Minutes of Pre-Bid Meeting for Advertised Tender Enquiry (ATE) for Procurement of Biological Safety Cabinet Class II A2 With Thimble /Canopy Connection and With UPS and Related Services for TB Laboratories across India

(Bid Ref. No.: SAMS/FIND India/G/2022/0097/Proc/Equipment/ATI/15/2022 dt. 16/01/2023)

Responses / Amendments (Amendment No. 1) with regard to queries/suggestions received for Advertised Tender Enquiry (ATE) for Advertised Tender Enquiry (ATE) for Procurement of Biological Safety Cabinet Class II A2 With Thimble /Canopy Connection and With UPS and Related Services For TB Laboratories Across India. (Bid Ref No.: SAMS/FIND India/G/2022/0097/Proc/Equipment/ATI/15/2022).

## Annexure B

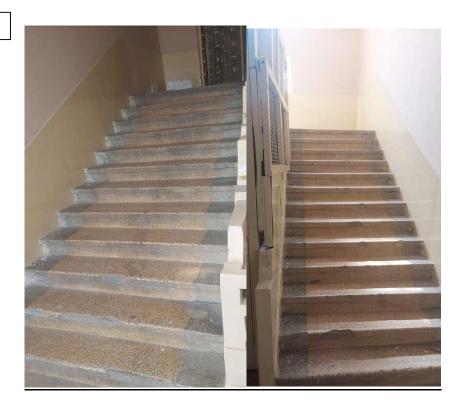
10.	General	-	Please share pictures and size of Staircase and service lift of sites, As biosafety cabinet is heavy weight machine and has a delicate glass window, which is breakable.	Pictures are attached in Annexure B.
